SUBJECT: Transmittal of Westinghouse Responses to US NRC Requests for Additional Information on the AP1000 Application for Design Certification

Westinghouse Non-Proprietary Response to US Nuclear Regulatory Commission
Requests for Additional Information dated April 2003

AP1000 DESIGN CERTIFICATION REVIEW

Response to Request For Additional Information

Figure 650.004-1 AP1000 IRWST Plan View

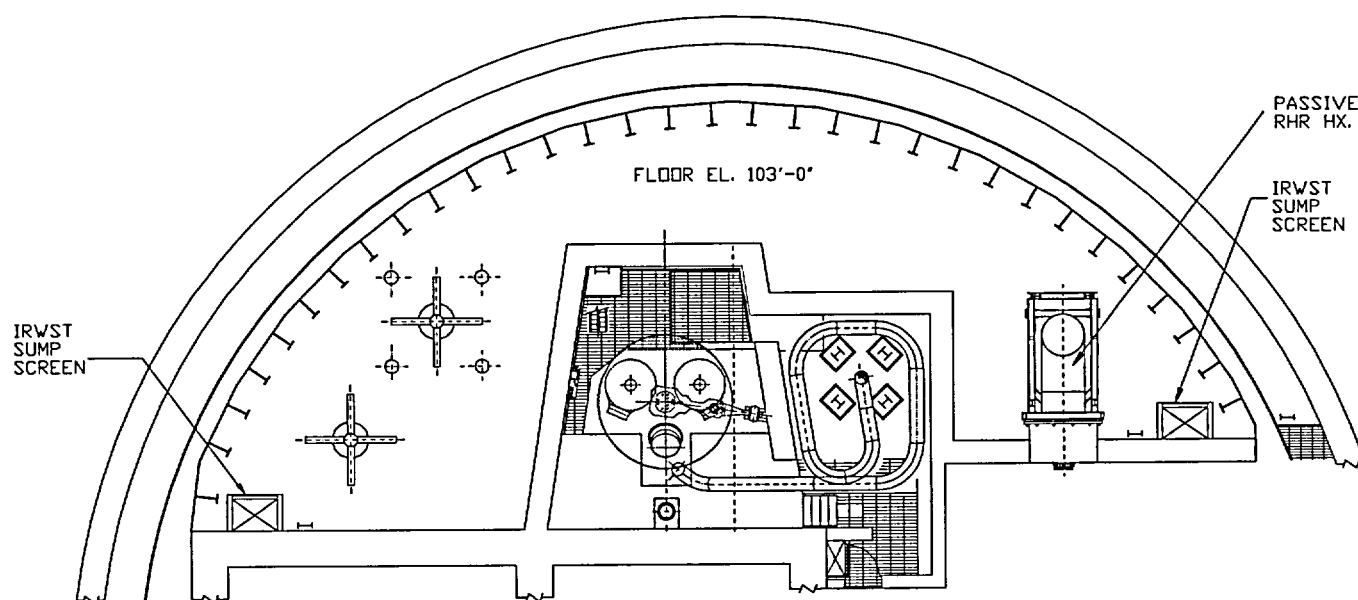
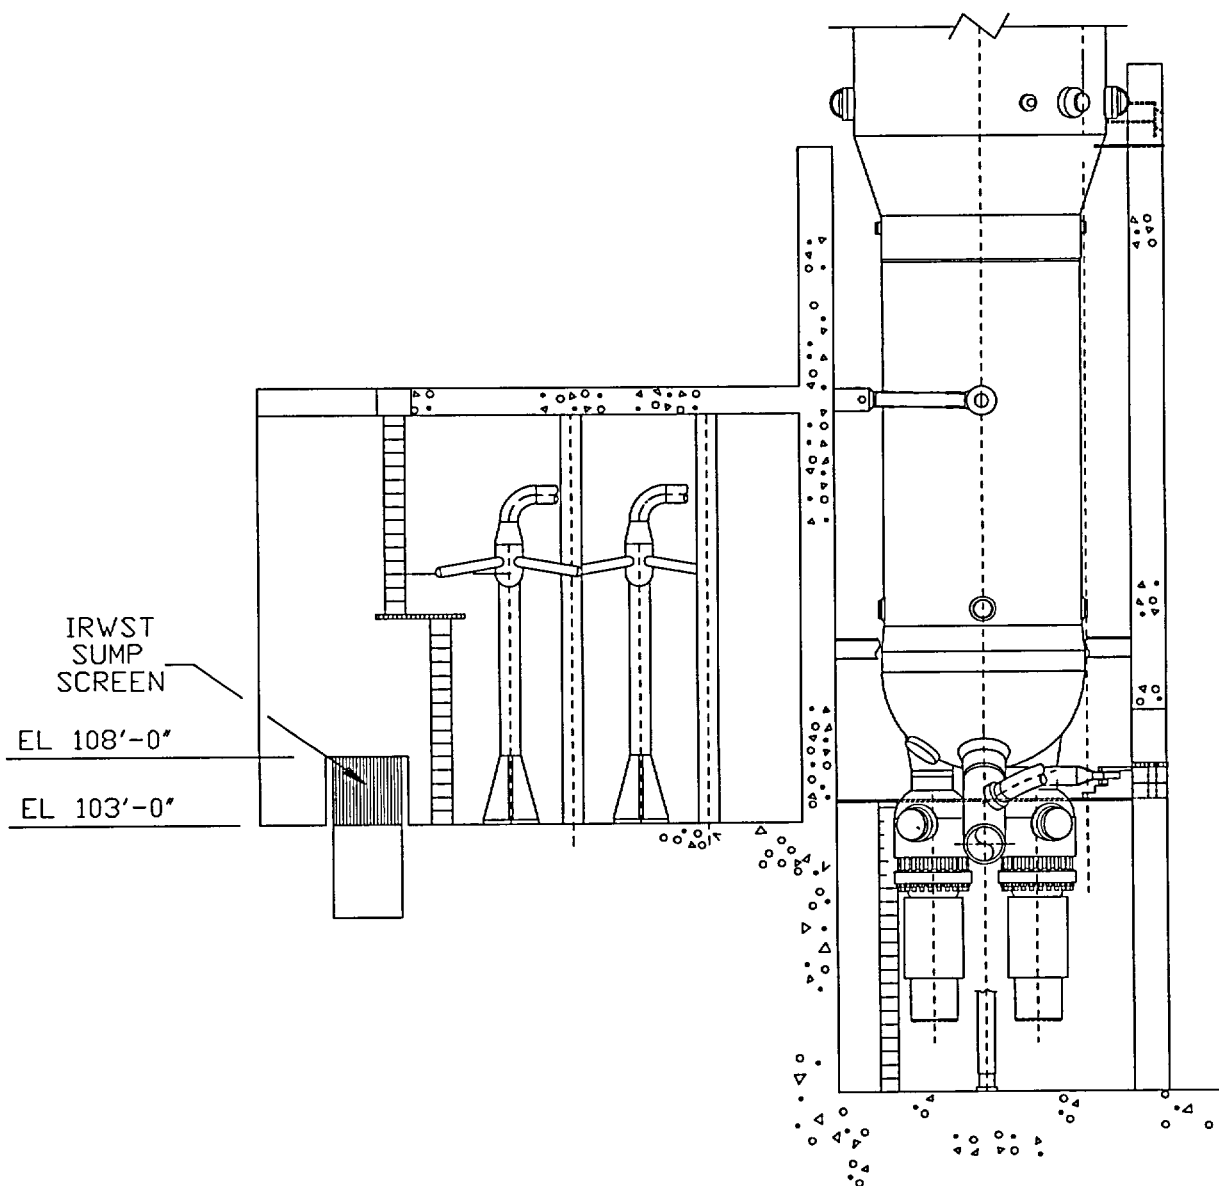
Section 6.3.2.2.3 of the DCD, entitled In-Containment Refueling Water Storage Tank, states that [t]he IRWST is stainless steel lined and does not contain material either in the tank or the recirculation path that could plug the outlet screens. Though the water in the IRWST would likely be relatively pure, the staff believes it is not likely to be completely free of debris, particularly considering the debris-concentrating potential afforded by the cycling of the IRWST inventory during refueling outages, and the opportunity for any suspended debris to settle to the IRWST floor during long periods of stagnation. The staff notes that as little as 1.5 cubic feet of fibrous debris could potentially cover both IRWST screens, which is a very small fraction of the tank's capacity of 73,900 cubic feet. If an automatic depressurization system (ADS) actuation occurs during an accident condition, any debris residing on the bottom of the tank (including heavier particulate matter) could be easily re-suspended by the consequent induced turbulence. Considering these NRC staff observations, please provide further information to clarify why fibrous and particulate debris settling onto the tank floor is not a concern for the IRWST screens, and clarify that the analysis concerning debris transport and head loss provided accounts for the most limiting IRWST conditions (e.g., during potentially turbulent conditions and at reduced tank levels as the switchover to recirculation approaches).

What is the basis for the conclusion in the RAI response that ". . . any resident debris that might have settled on the IRWST floor prior to an accident is not likely to be stirred up by the ADS . . . ?" That is, what sort of analysis has been done to demonstrate that the turbulence conditions within the IRWST are sufficiently low at the floor of the tank during an ADS actuation?

The IRWST is a stainless steel lined storage tank located inside containment. Refer to Figure 650.004-1 and -2. The tank is normally closed off from the containment although there are large louvered vents located through the IRWST roof. The tank is 30.25 feet high (inside floor to ceiling). The tank extends around part of the containment from the refueling cavity past the pressurizer and is about 120 feet across. There are two ADS spargers located in one side of the tank. The bottom of the sparger arms are located about 16 feet above the floor of the tank. There are two separate PXS injection line connections from the bottom of the IRWST. Line A is on the ADS side and line B is on the other side with the PRHR HX. Each of these lines is protected by a screen assembly. Line A has a connection to the Spent Fuel Pool Cooling System (SFS) pumps. This line allows the SFS to recirculate the water in the IRWST to provide

As discussed above significant quantities of debris are not expected to settle out in the IRWST during normal operations. Even if such debris ~~did~~ were to have settled onto the IRWST floor, they are ~~it~~ is not expected to be stirred up in the limiting accident. **The basis for this statement is the discussion of the ADS design and plant behavior presented below and the observation of test results from the Low-Pressure Integral Systems Test at Oregon State University. OSU has a scaled ADS sparger. OSU test SB-12 is a DVI LOCA; it shows that the temperature near the bottom of the IRWST (below the PRHR HX bottom) shows essentially no temperature change out through ADS 4 actuation (Reference 1). Although this test was performed for AP600, the design of the IRWST, the ADS sparger and ADS stages 1, 2, 3 have not been changed for AP1000. As a result, the conclusions also apply to the AP1000.**

Figure 650.006-1 AP1000 Coating Debris Settling (Front)

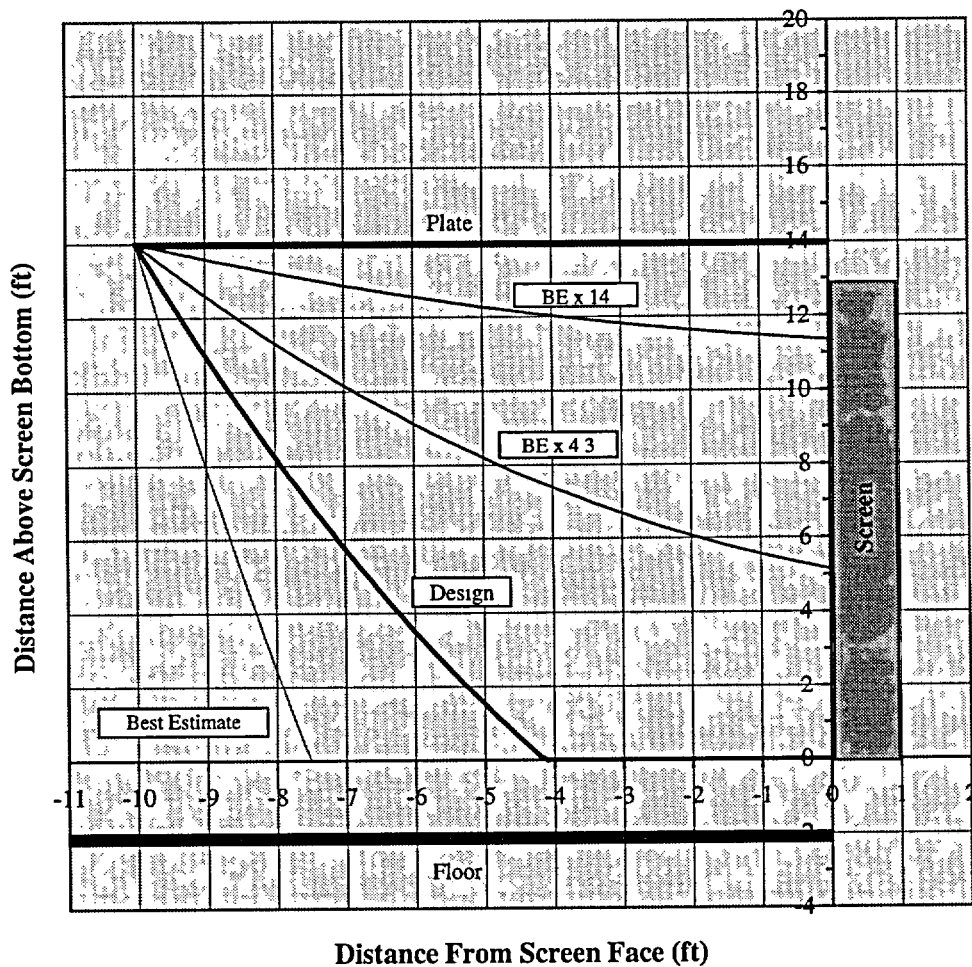
During the NRC staff's review of the AP600, an open item identified as OITS #6590 was generated. Westinghouse responded to this open item in three parts. Please confirm whether or not the second and third parts of the response to OITS #6590 also apply to the AP1000 design. Specifically, (a) would the complete failure of the non-safety-related coatings block any portion of the AP1000 recirculation screens? and (b) is a combined license (COL) action required for the AP1000 that an analysis must be performed of coating debris generation and transport that is based upon appropriate test data?

What is the basis for using 200 mils as the diameter for postulated coating debris? Experience shows that much smaller flakes are possible, and smaller flakes would tend to settle more slowly than would the larger diameter flakes assumed in the calculation, presenting a potentially greater challenge to the sump screen. When potential resident fiber loadings are considered, flakes significantly smaller in diameter than 200 mils are presumably large enough to become trapped at the interstitial locations of the lattice formed by a fibrous debris bed. Although they presumably represent particles smaller than 200 mils, it is not clear exactly what flake sizes correspond to the bounding settling calculations (i.e., B.E. x 4.3, B.E. x 14), and thus it is not clear what degree of conservatism is being employed when considering the sizes of flakes that can be generated through known failure mechanisms.

Figures 650.006-1 and -2 show the settling trajectories of coating debris starting at the edge of the protective plate. Figure 650.006-1 shows the approach from the front of the screen and figure 650.006-2 shows the approach from the side. Such debris can not enter the water any closer to the screens because no coatings are permitted any closer to the screens. The figure shows that with design settling rates the debris will settle to the elevation of the bottom of the screen after drifting about 6 feet, which is at about 4 feet away from the screen. Significant conservatism was included in this evaluation, including assuming the lightest/smallest coating debris. **The minimum debris size was selected as a disc 200 mils in diameter and 5 mils thick. The 200 mils was selected as the smallest size that**

It also assumes the maximum recirculation flow of 1600 gpm, consistent with the maximum flow from two RNS pump operating unthrottled with suction taken from two screens. Another area where significant margin has been applied is in the debris settling rates. AP1000 uses debris settling rates that contain a factor of two margin compared to the reference settling data (Reference 1) which is sufficient to account for uncertainties. Without this added margin, the coating debris settles out very quickly in less than 3 feet, as shown in Figure 650.006-1 and -2.

The debris settling shown in figures 650.006-1 and -2 provide confidence that the plant can sustain complete failure of the nonsafety-related coatings located inside containment without excessive blockage of the recirculation screens.
